Viking CCS Pipeline

9.40 Design Changes 3 and 4: Environmental Technical Note

Document Reference: EN070008/EXAM/9.40

FIGURE TITLE
Figure 1
Design Change 3 - Relocation of Block Valve Station 3

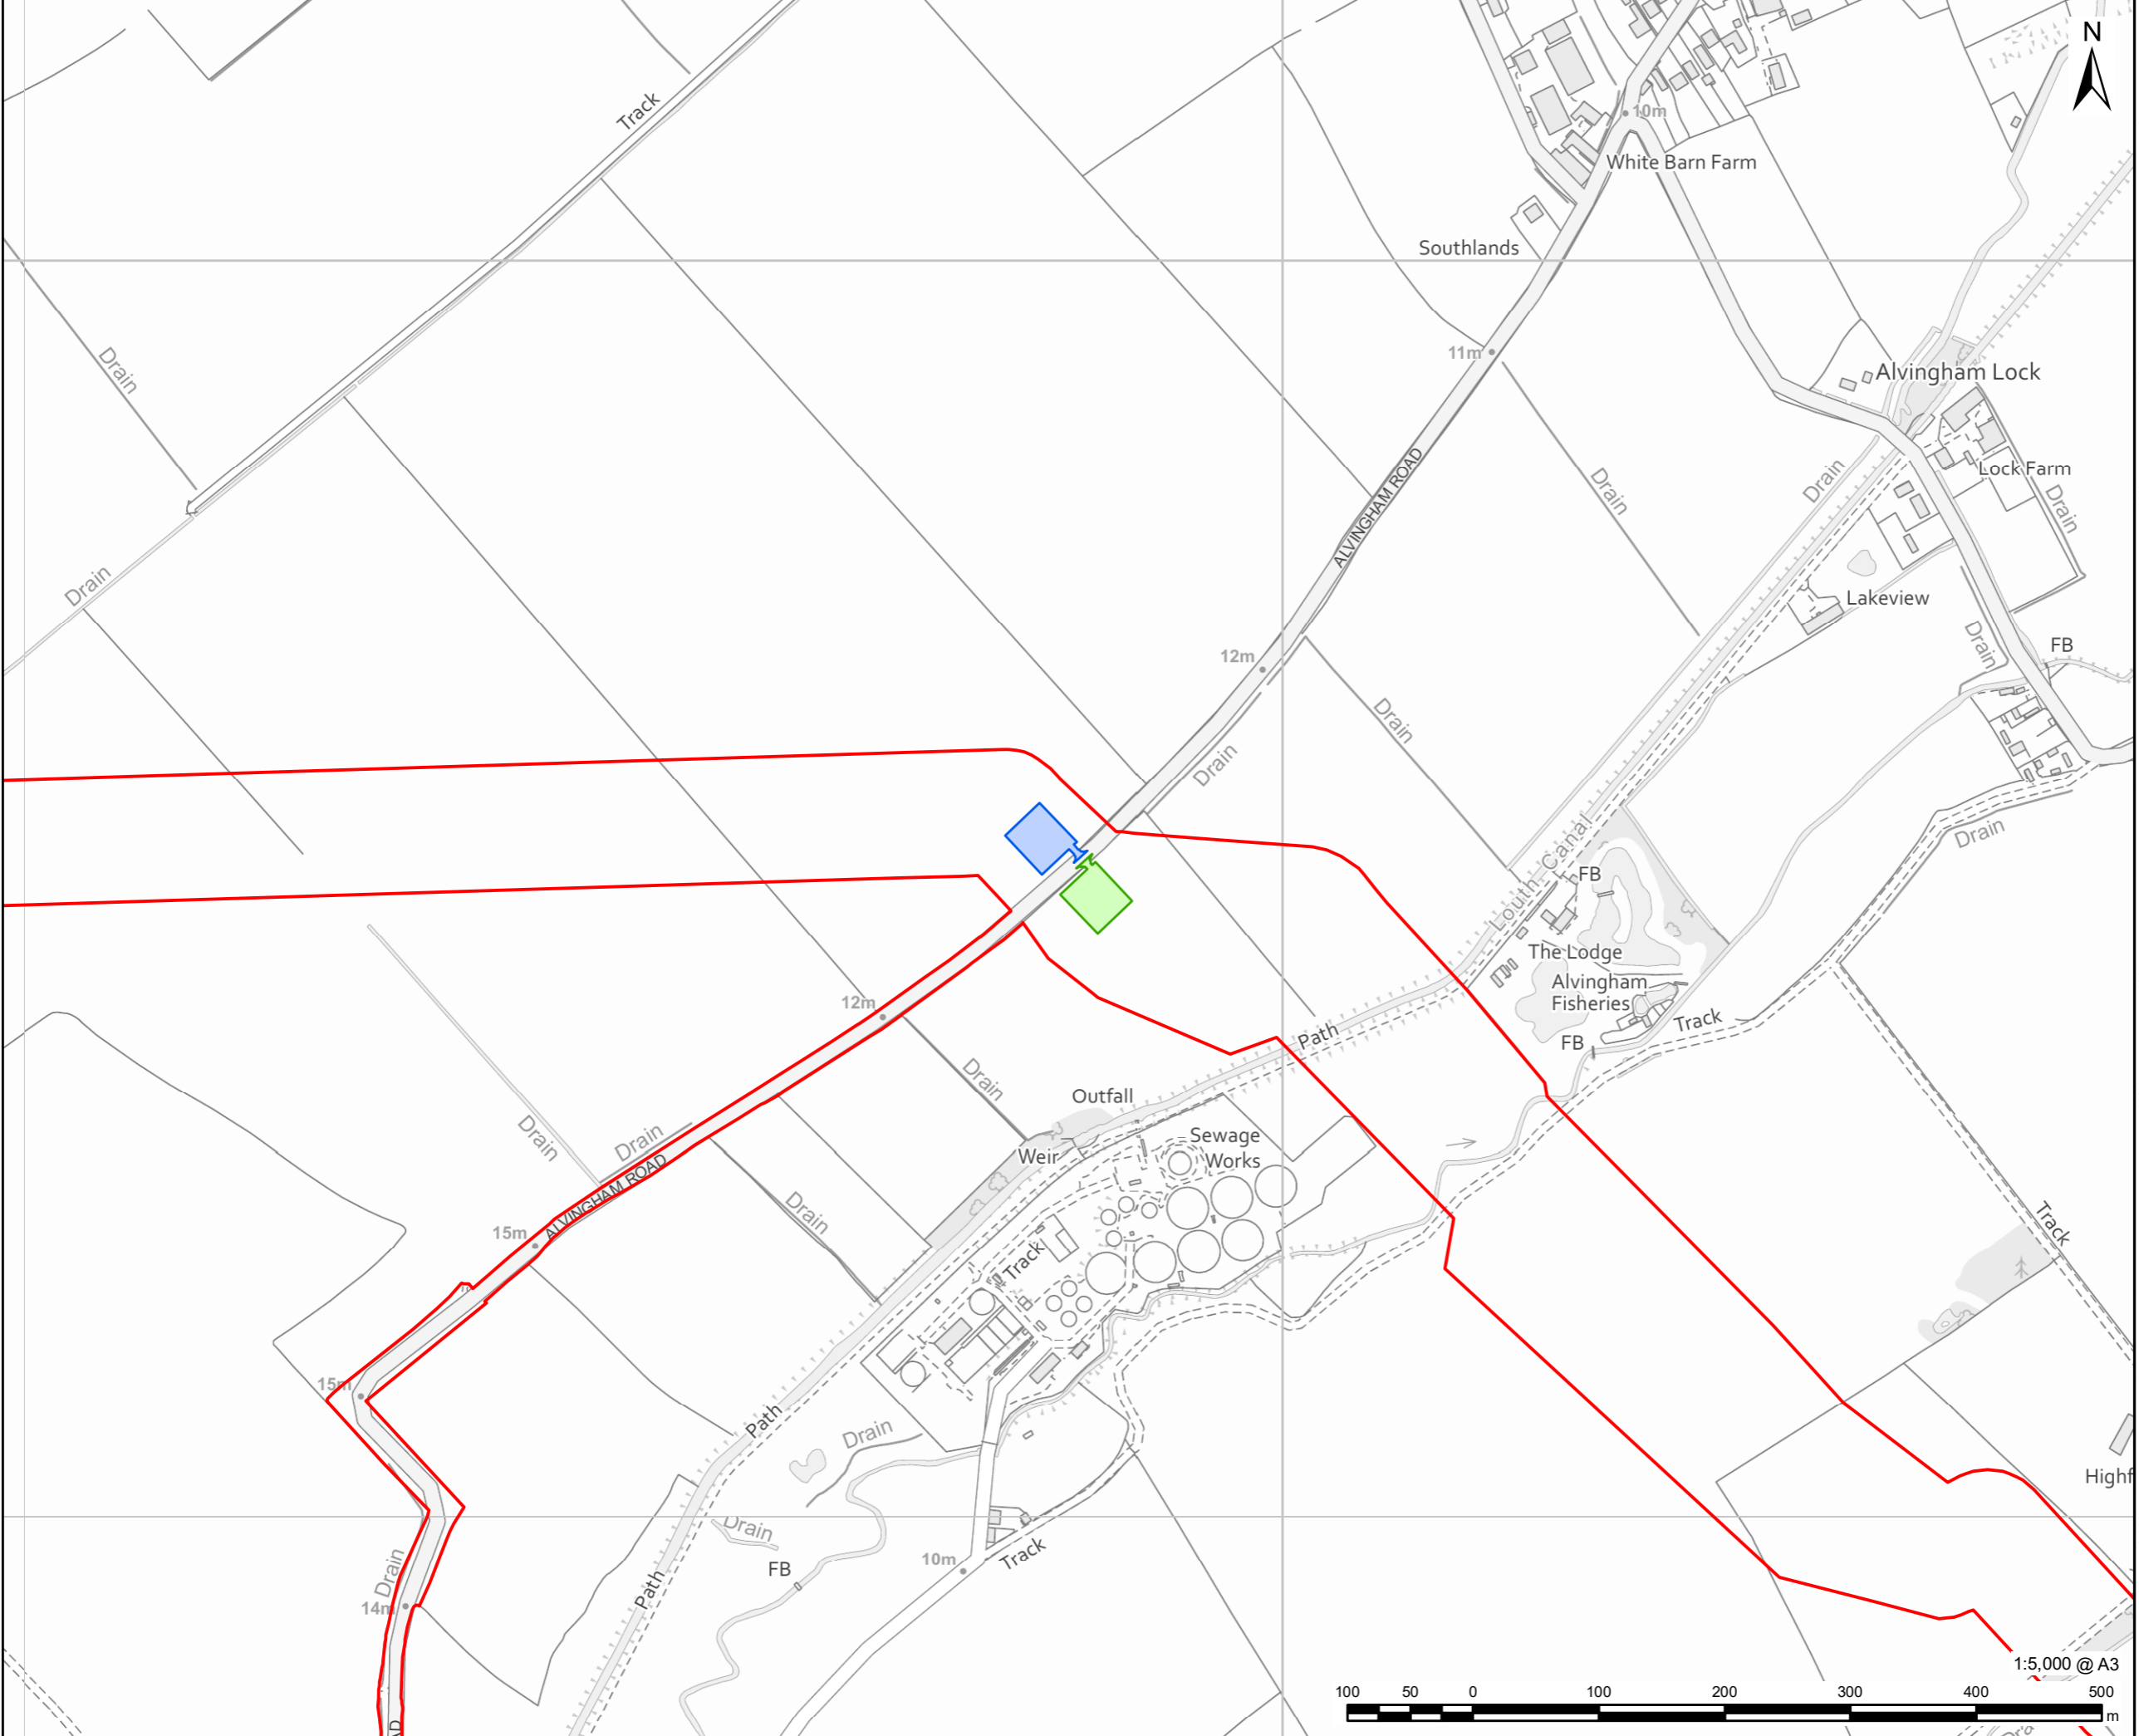
- The proposed location of Block Valve Station 3 is proposed to be moved from arable land north east of Louth Road, approximately 20 m south to arable land south east of Louth Road. Importantly, this change does not require any change to the Order Limits for the Proposed Development;
- The Block Valve Station would have a permanent access point off the south side of Louth Road, rather than to the north;
- A proposed temporary access and laydown area that was originally south east of Louth Road would be relocated to the north west side of Louth Road; and
- As outlined within the Applicant's response to the first written Questions [REP1-045], it has been confirmed that the physical footprint of all Block Valve Station's will be approximately 43 metres x 38 metres (rather than the originally quoted 50m x 40 m in paragraph 3.8.15 in APP-045).

2.2.3 **Figure 1** provides a close-up overview of the change in location of Block Valve Station 3, whilst **Figure 2** provides an updated version of Figure 3-10 as originally presented within ES Volume II Chapter 3: Description of the Proposed Development [APP-045]. **Figure 3** shows the indicative layout of Block Valve Station 3, with only the orientation changed. **Figure 4** shows the new location of the temporary access and laydown area, compared to the original location.

Figure 3: Indicative layout of Block Valve Station 3 (Louth Road BVS)

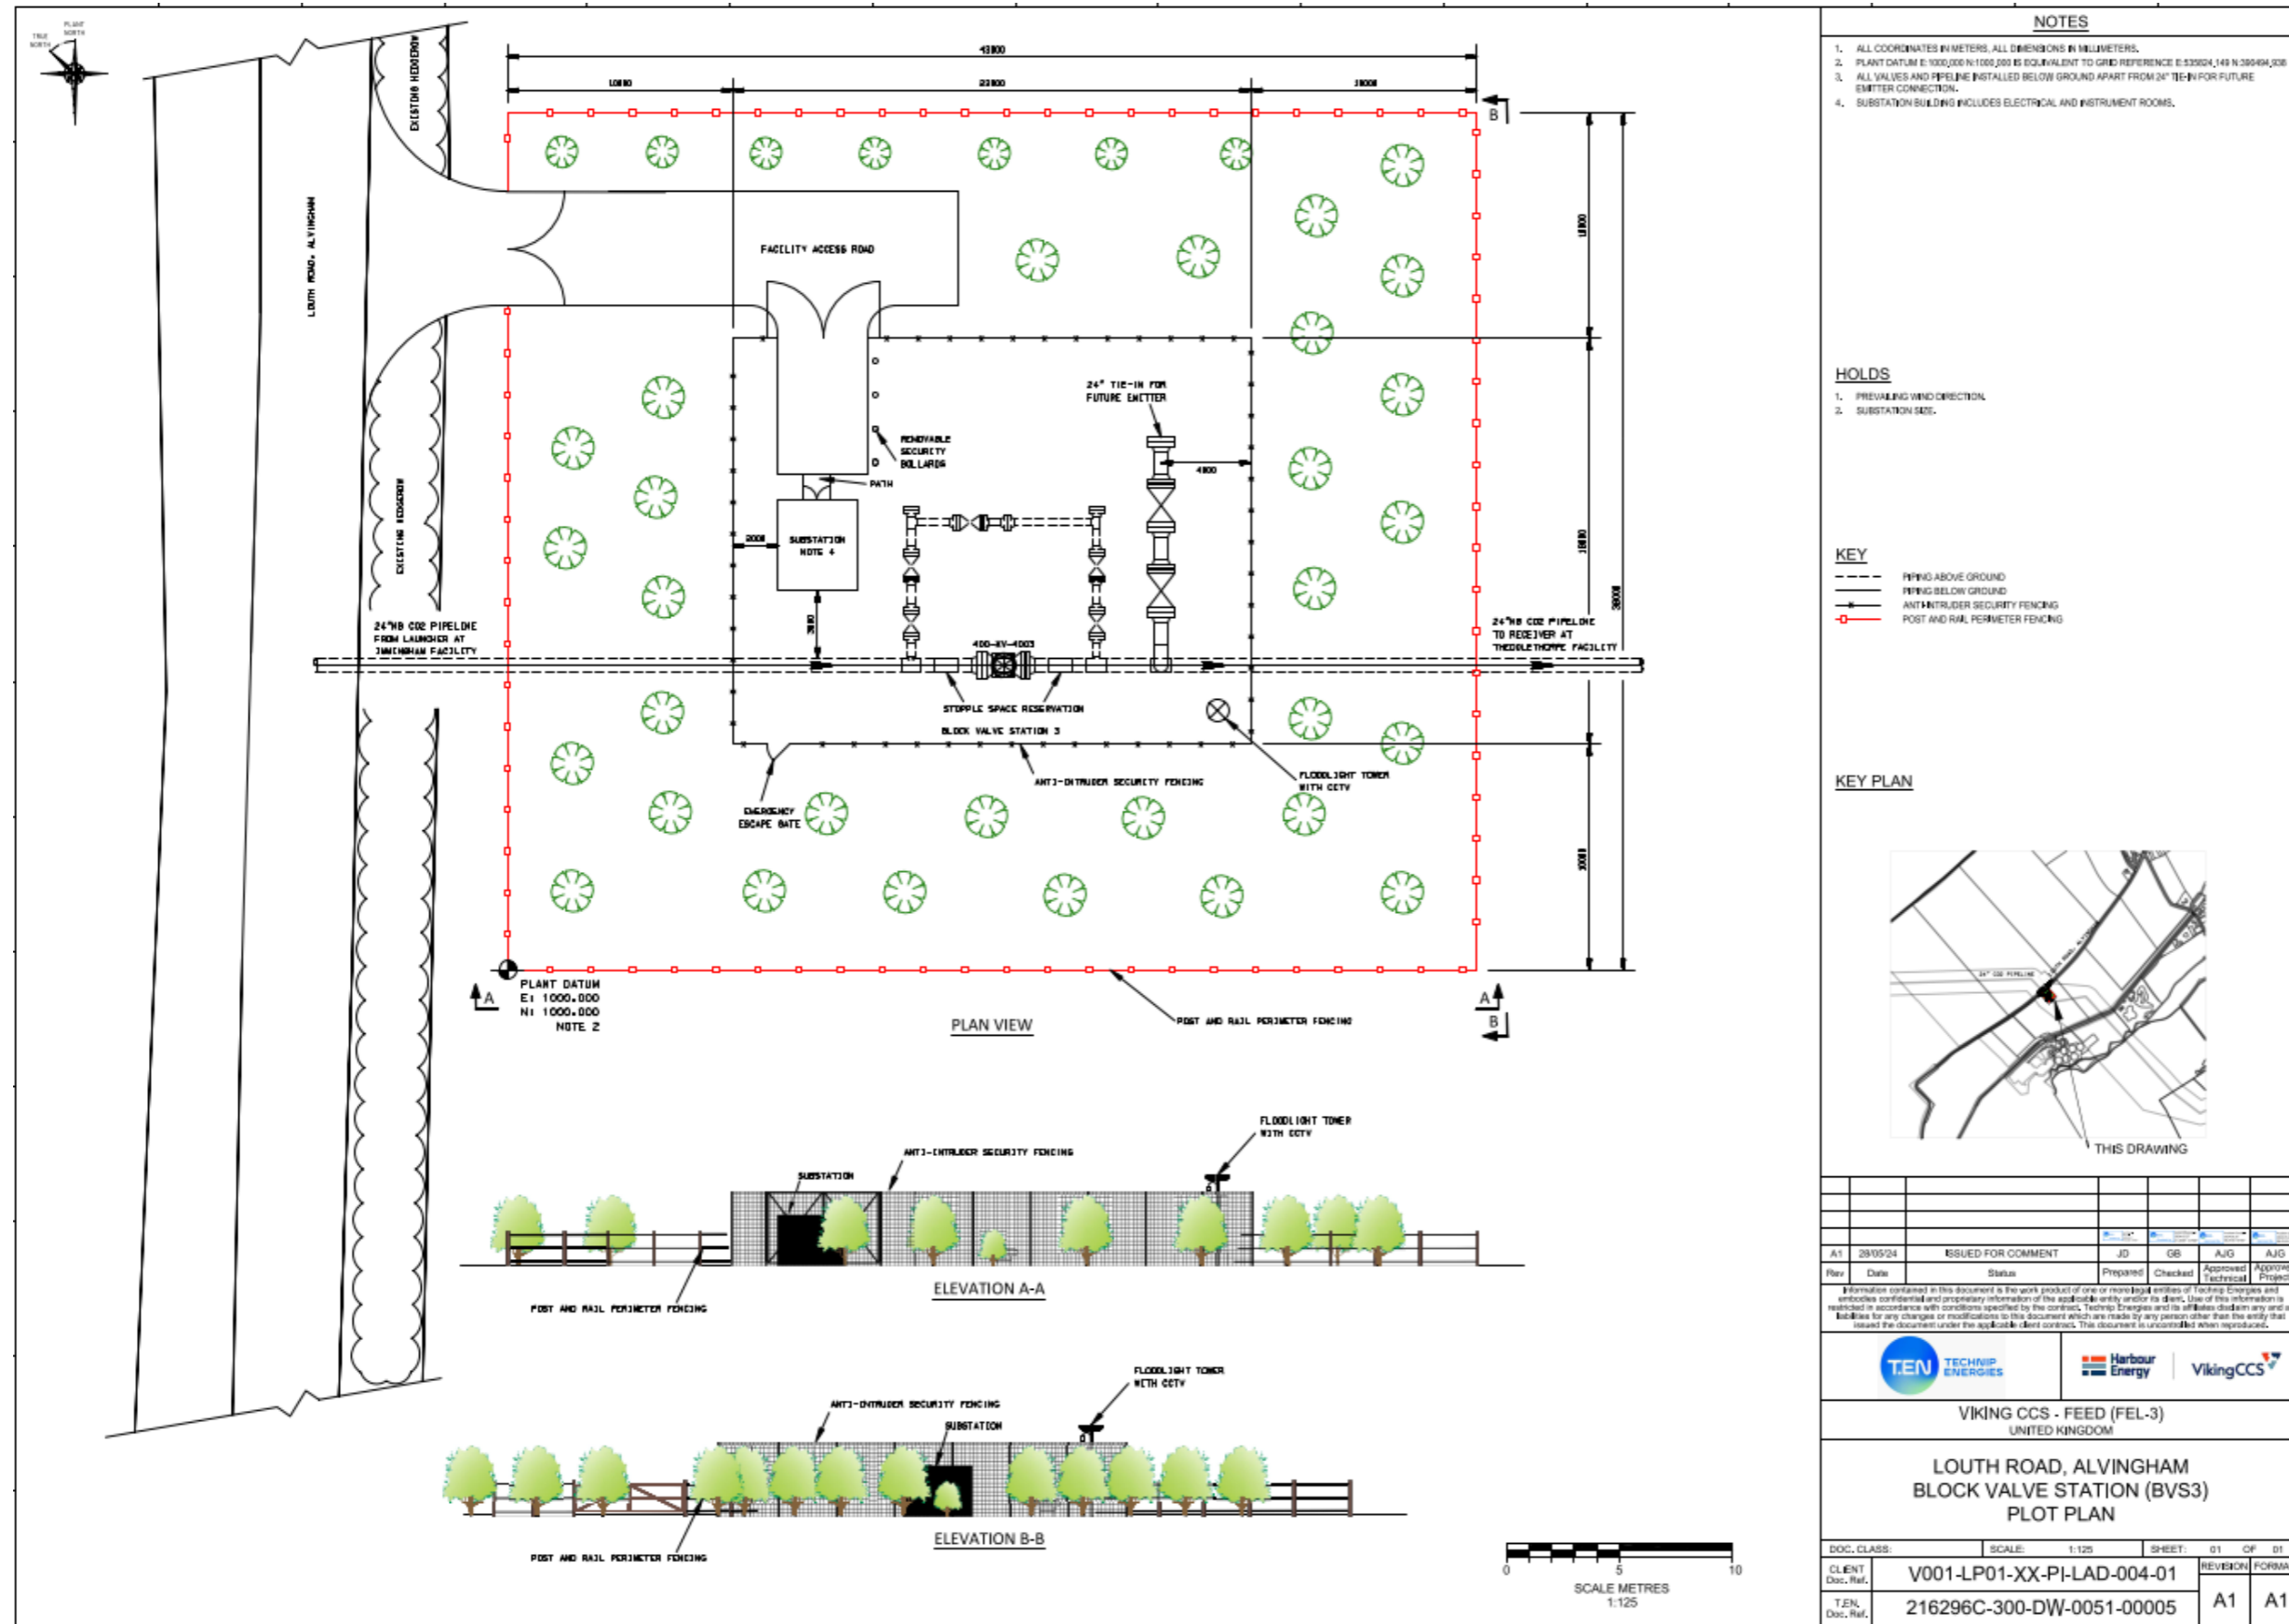
- The anticipated appearance is expected to remain the same as that shown in Figure 3-14 of ES Volume II Chapter 3: Description of the Proposed Development [APP-045], with the orientation updated to reflect its new location as shown in **Figure 3**.
